TSB150060

New Crankcase Breather Tube Hose Clamps for Part Option BR9277

Figure 1, Number 1 Left: Spring Hose Clamp, Part Number 3925089. Number 2 Right: Worm Hose Clamp, Part Number 43828.

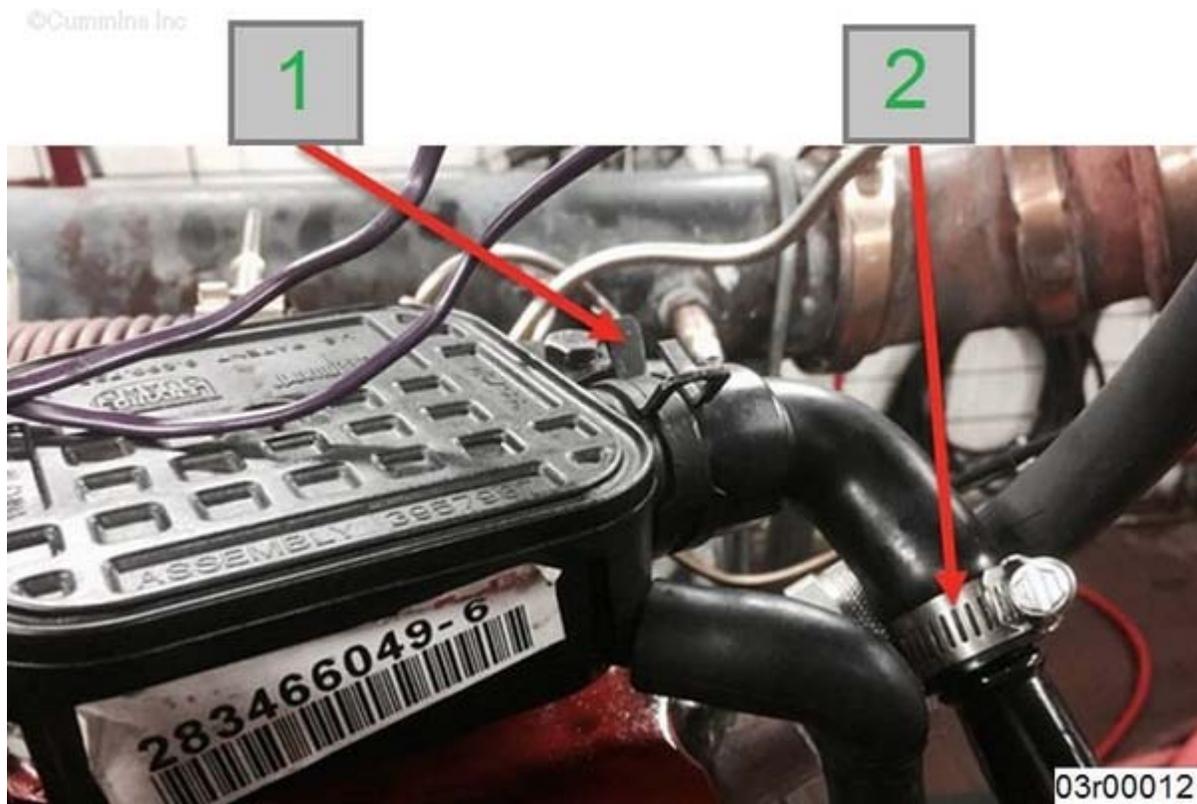
A spring loaded hose clamp, Part Number 3925089, has been released for the connection from the crankcase breather assembly to molded elbow.

The worm gear hose clamp, Part Number 0043828, has been released for the connection from the molded elbow to crankcase breather tube.

Under conditions of excessive engine crankcase pressures, the ninety degree elbow of the crankcase ventilation tube can detach from the crankcase breather assembly.

Cummins Inc. recommends that the new hose clamps, Part Numbers 3925089 and 0043828, be installed on both ends of the ninety degree elbow of the crankcase breather tube to prevent the crankcase breather tube from possibly detaching during high crankcase pressure conditions.
